XV Compressors with Added Power Factor Correction

Secop will be introducing the XV attached electronic unit with PFC to the market to comply with the latest EU standards.

Fig. 2 On the left: voltage and current after power on [electronic unit 105N5020/22].
On the right: voltage and current after power on with added Power Factor Correction [electronic unit 105N5320].

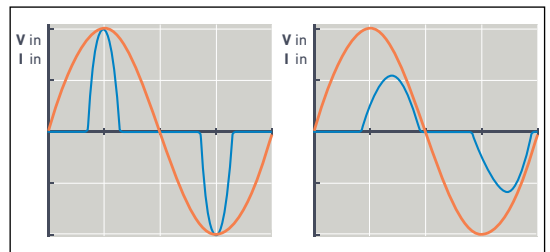
An appliance using a variable speed compressor must comply with EN 61000-3-2:2015 when released after June 30, 2017.

It must be equipped with a Power Factor Correction (PFC) function to be able to comply with the harmonics limits (see figure 2).

The XV attached electronic units 105N5020 and 105N5022 must be replaced by 105N5320 when used in the EU.

Fig. 4 New 105N5320 electronic unit without cover.

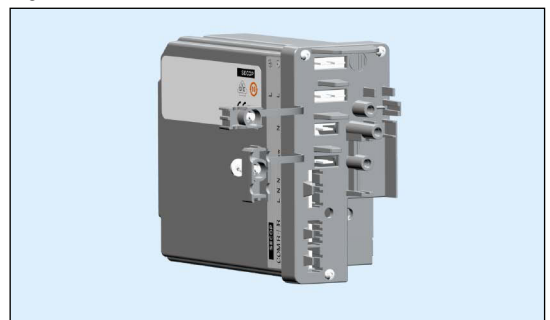
The PFC function normally requires more space, but Secop has managed to keep the size unchanged and designed a new housing with the same size as the existing 105N5020/22 housings (see figure 3 and 4).
